Subject: Defining Targets/Initiators as Ports

The following show the changes in SAM-2 that would be required to change to support a port = target/initiator model.

Figure 2 — SCSI I/O system and domain model

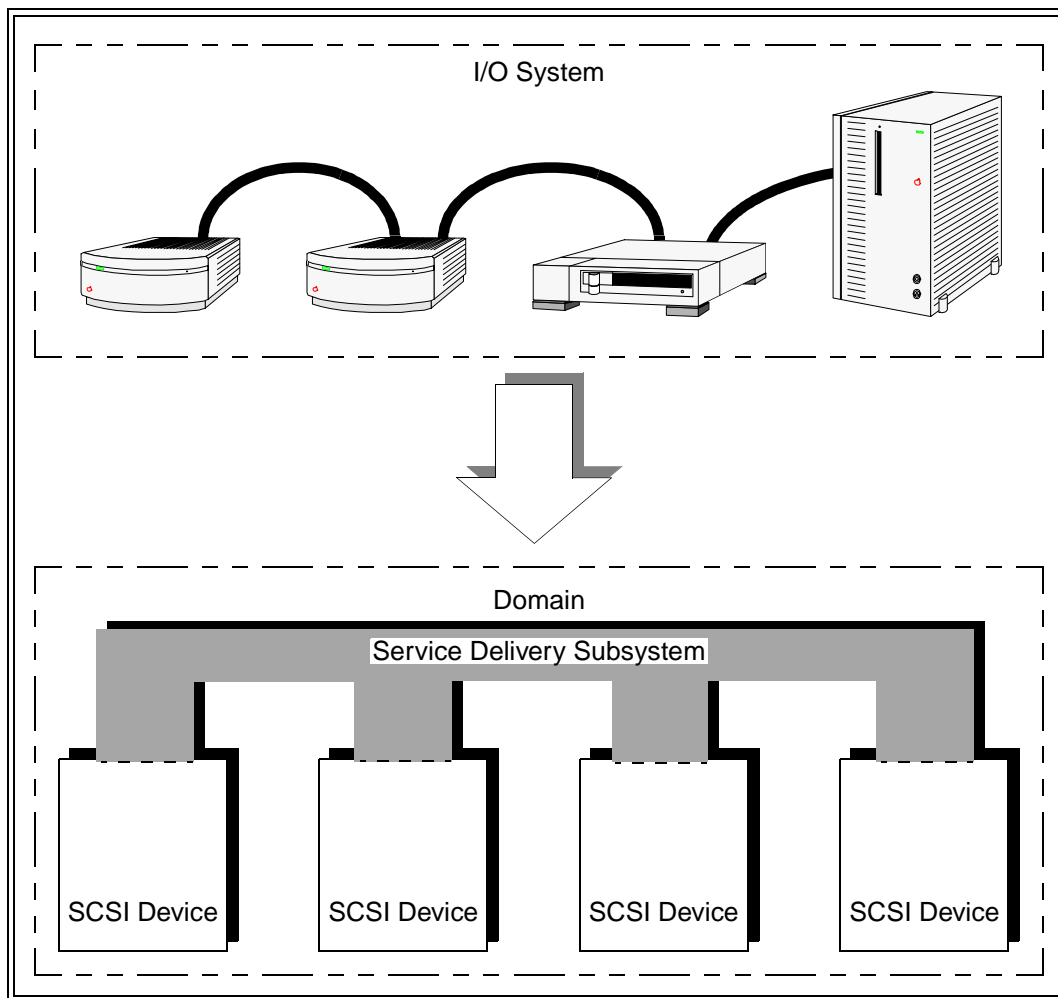
The SCSI structural model represents a view of the elements comprising ~~an a~~ SCSI I/O system as seen by the application clients interacting with the system through the service delivery ~~port~~ subsystem. In an implementation, this view is similar to that seen by a CAM device driver interacting with the system through the CAM SIM layer. This model is defined as a hierarchy of objects. As shown in figure 2, the fundamental object is the SCSI domain, which represents an I/O system. A domain is made up of SCSI devices and a service delivery subsystem, which transports commands and data. ~~An A~~ SCSI device, in turn, may consist of logical units and so forth.

Figure 4 — Domain hierarchy

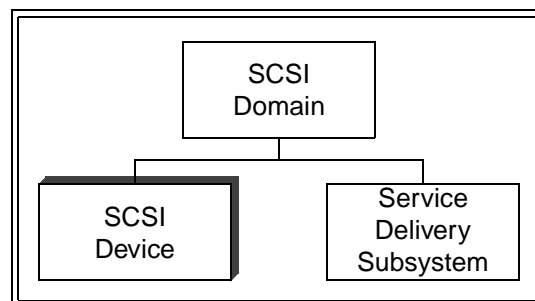
An ~~A~~ SCSI domain is composed of ~~two or more SCSI devices and target ports and initiator ports interconnected by~~ a ~~Service Delivery Subsystem~~. ~~Figure 7 shows a functional model of a SCSI domain corresponding to the SCSI I/O system model shown in figure 2~~~~service delivery subsystem~~. Figure 4 shows the hierarchy of SCSI domain objects.

Figure 6 — Initiator hierarchy diagram

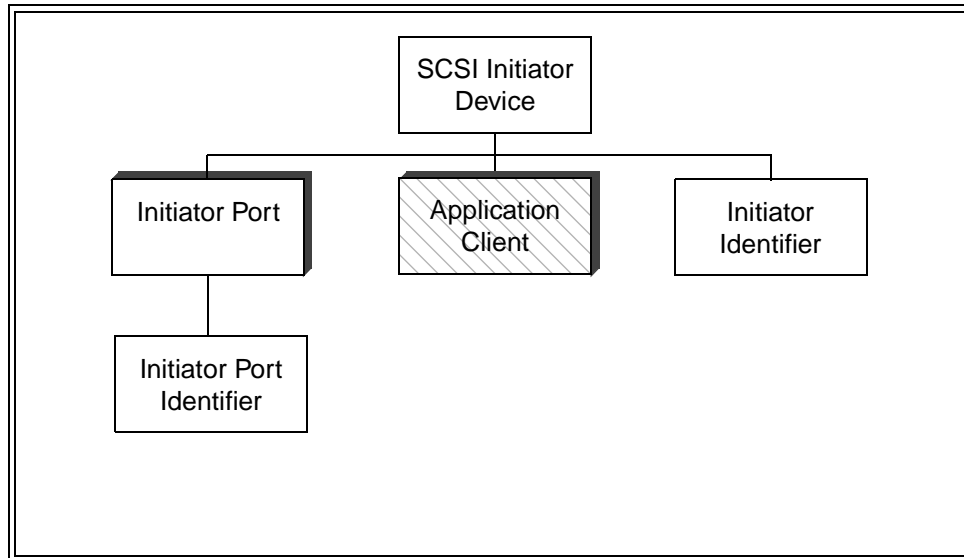
A SCSI initiator device (see figure 6) contains:

- a) ~~A SCSI initiator device (see figure 6) contains one or more initiator ports each having~~ containing an initiator ~~identifier and zero or more application clients;~~ port identifier;
- b) ~~zero or more application clients; and~~ zero or more application clients; and
- c) ~~an initiator identifier.~~ an initiator identifier.

An initiator identifier is a value ~~containing up to 64 bits~~ that is the SCSI device identifier for ~~an initiator port~~. ~~An application client is the source of commands and task management functions. A~~ a SCSI initiator device ~~contains is one application client for each pending command or task management function~~ device.

An initiator port identifier is a value that is the SCSI port identifier for an initiator port.

An application client is the source of commands and task management functions. A SCSI initiator device contains one application client for each pending command or task management function.

**Figure 7 — Target hierarchy diagram**

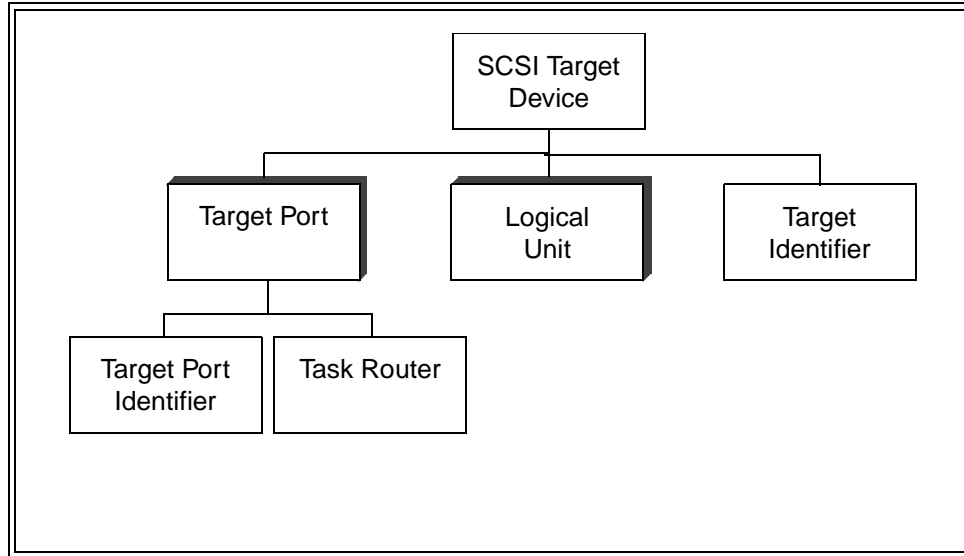
A SCSI target device (see figure 7) contains:

- a) ~~A SCSI target device (see figure 7) contains of one more target ports composed of each~~ containing a task router and target ~~identifier and one or more logical units~~ port identifier;
- b) a target identifier; and
- c) one or more logical units.

~~A target identifier is a value containing up to 64 bits that is a SCSI device identifier for a target port. A task router moves the commands and task management functions between the service delivery subsystem and the appropriate logical logical. A logical unit (see) is the object to which SCSI commands are addressed. One of the logical units within the SCSI target device shall be addressed using the logical unit number zero. SCSI target/initiator model.~~

[A target identifier is a value that is the SCSI device identifier for a SCSI target device.](#)

[A target port identifier is a value that is a SCSI port identifier for a target port.](#)

[A task router moves the commands and task management functions between the service delivery subsystem and the appropriate logical unit's task manager.](#)

Figure 8 — Target/Initiator hierarchy diagram

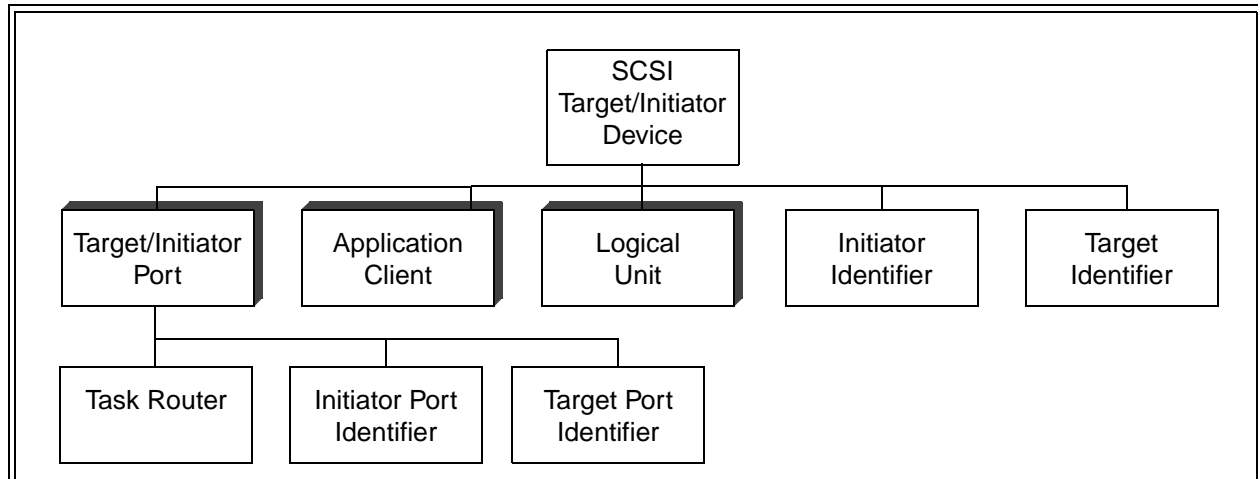
~~A SCSI target/initiator device (see figure 7) contains of one or more target/initiator ports composed of a task router and target/initiator identifier and one or more logical units.~~

[A SCSI target/initiator device \(see figure 7\) contains:](#)

- a) [one more target/initiator ports each containing a task router, target port identifier, and an initiator port identifier;](#)
- b) [one or more logical units; and](#)
- c) [zero or more application clients.](#)

[The target identifier and the initiator identifier are values containing a SCSI device identifier for a target/initiator device.](#)

The ~~target/target port identifier and the~~ initiator ~~port~~ identifier ~~is a value~~ [are values](#) containing ~~up to 64 bits that is a SCSI device~~ identifier for a target/initiator port.

**Figure 9 — SCSI device functional models**

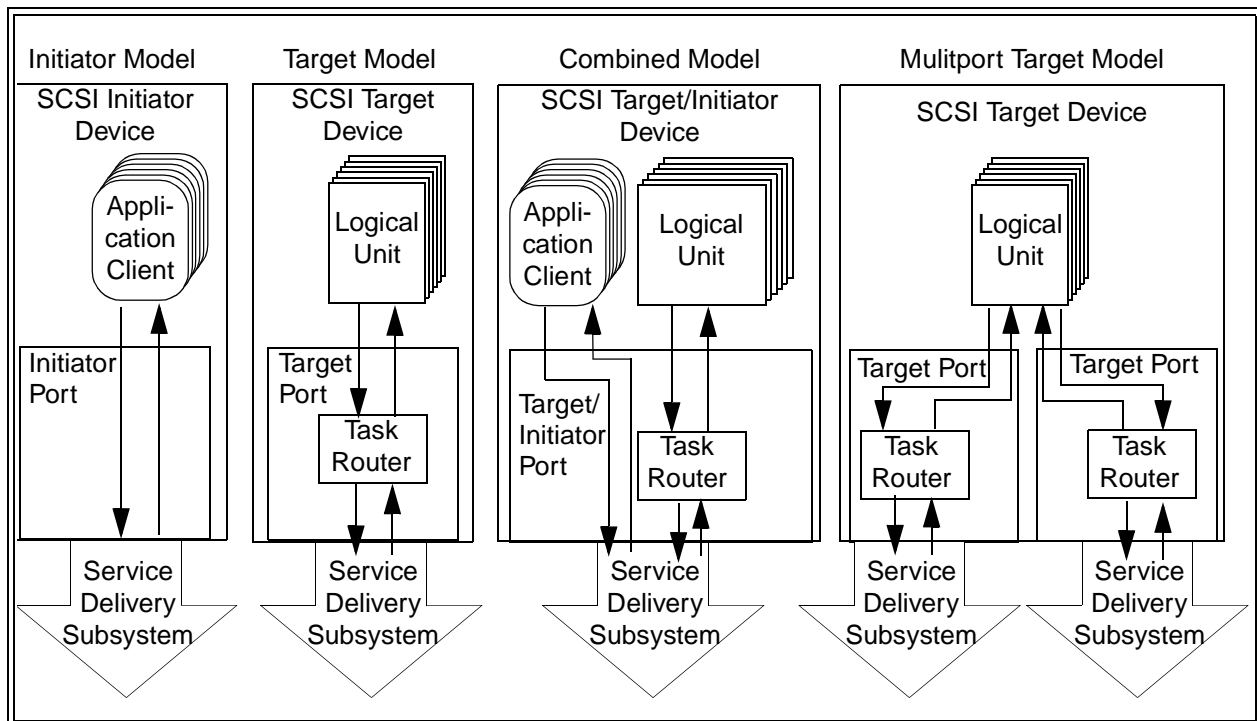
There are several models for implementing ports in ~~an~~ a SCSI device, some are shown in figure 9. A SCSI device may contain only target ports, only initiator ports, only target/initiator ports or any combination thereof.

**Figure 10 — Logical Unit hierarchy diagram**

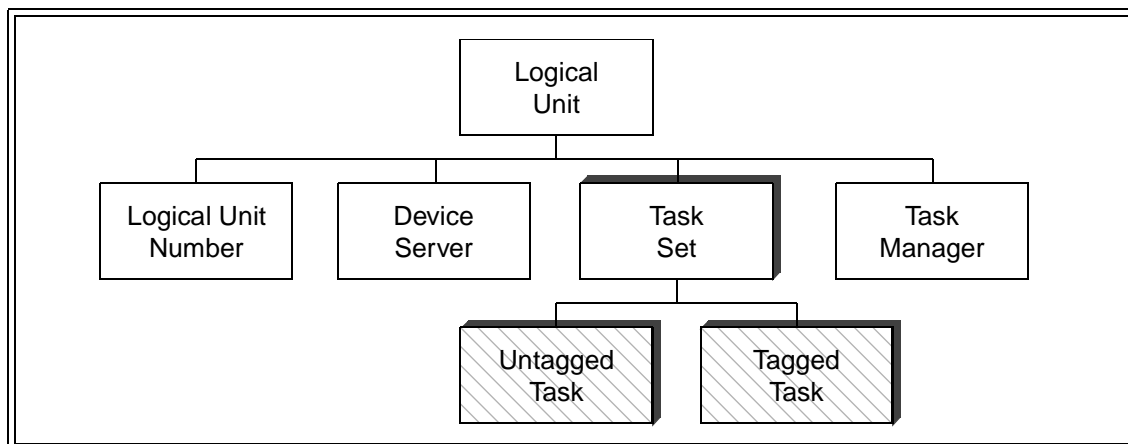
~~A logical unit (see figure 10) is composed of a logical unit number, a device server, a task manager, and one or more task sets~~ A logical unit (see figure 10) contains:

- a) A logical unit number;
- b) a device server;
- c) a task manager; and
- d) one or more task sets each may contain zero or more untagged tasks or a combination of zero or more tagged tasks and zero or more untagged tasks.

**Figure 11 — Multiple port target SCSI device structure model**

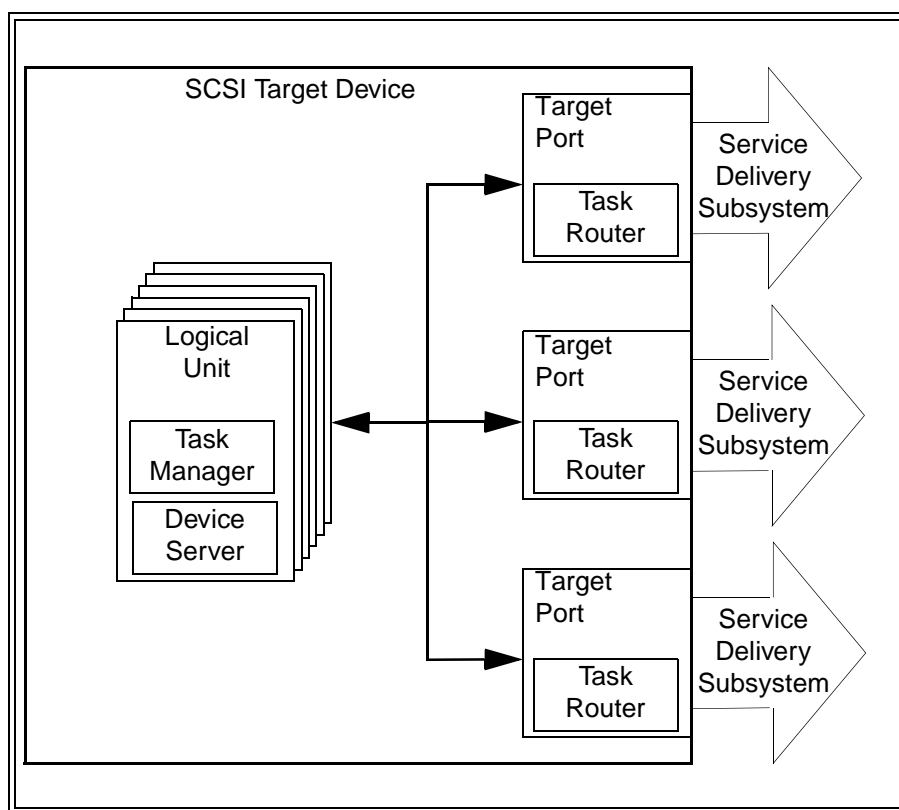
~~Figure 10~~ **Figure 11** shows the structure of a SCSI target device with multiple target ports. Each target port ~~consists of a task router and~~ is shared by a collection of logical ~~units~~ ~~units and contains of a task router~~. Each logical unit contains a single task manager and a device server.

**Figure 12 — Multiple port SCSI initiator device structure model**

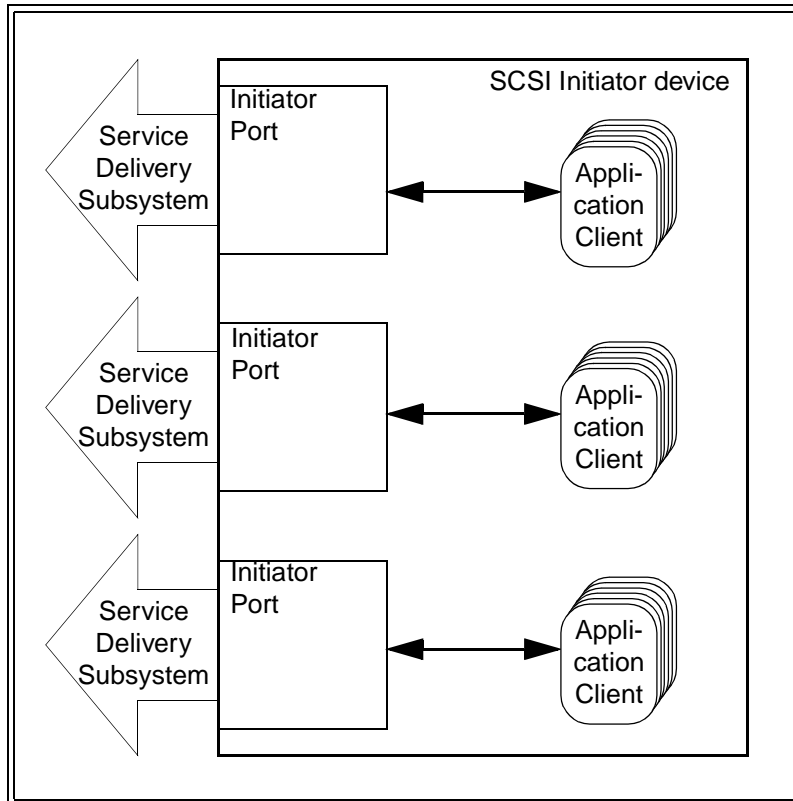
**Figure 11** shows the structure of a SCSI initiator device with multiple initiator ports. Each initiator port is shared by a collection of application clients.

**Figure 13 — Multiple port target/initiator SCSI device structure model**

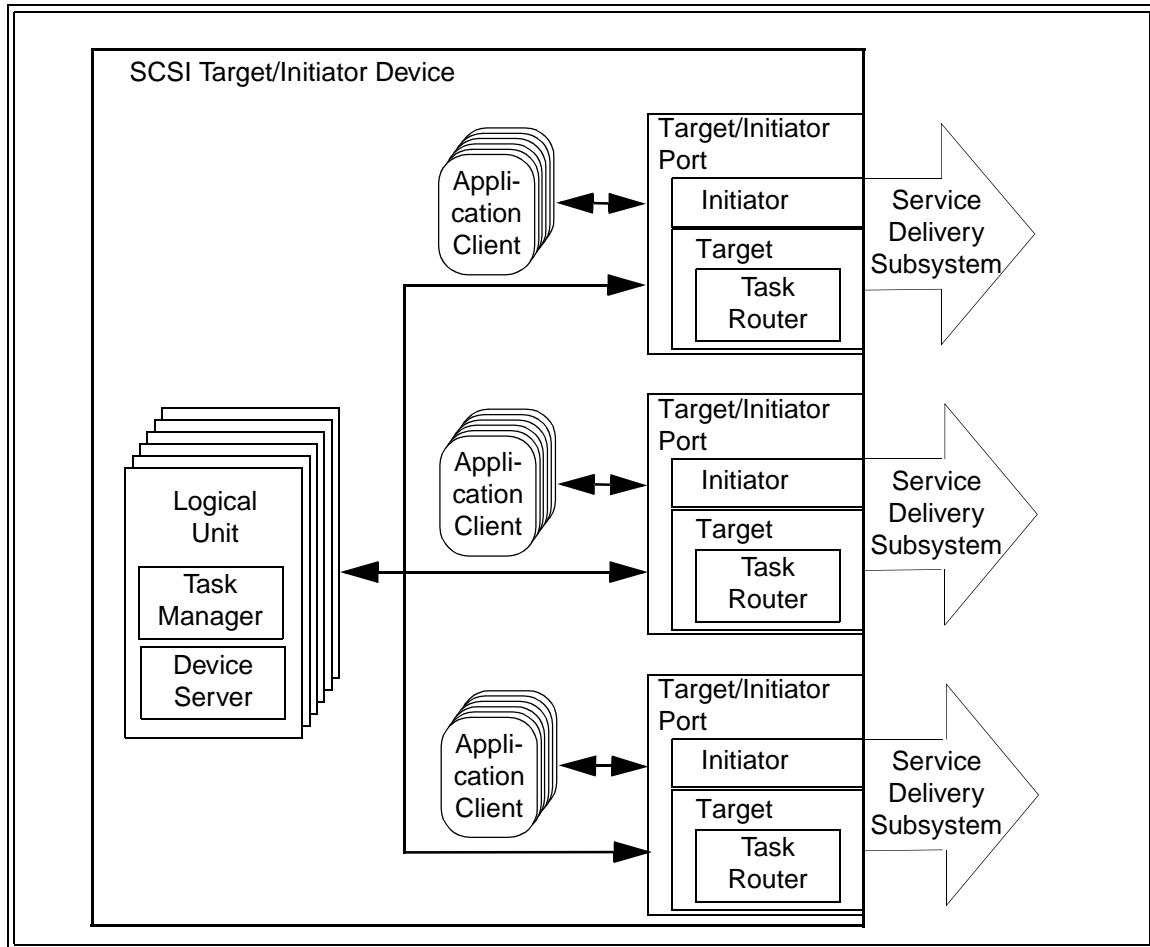
**Figure 11** shows the structure of a SCSI target/initiator device with multiple target/initiator ports. Each target/initiator port consists of a task router and is shared by a collection of logical units. Each logical unit contains a single task manager, a device server, and an application client.
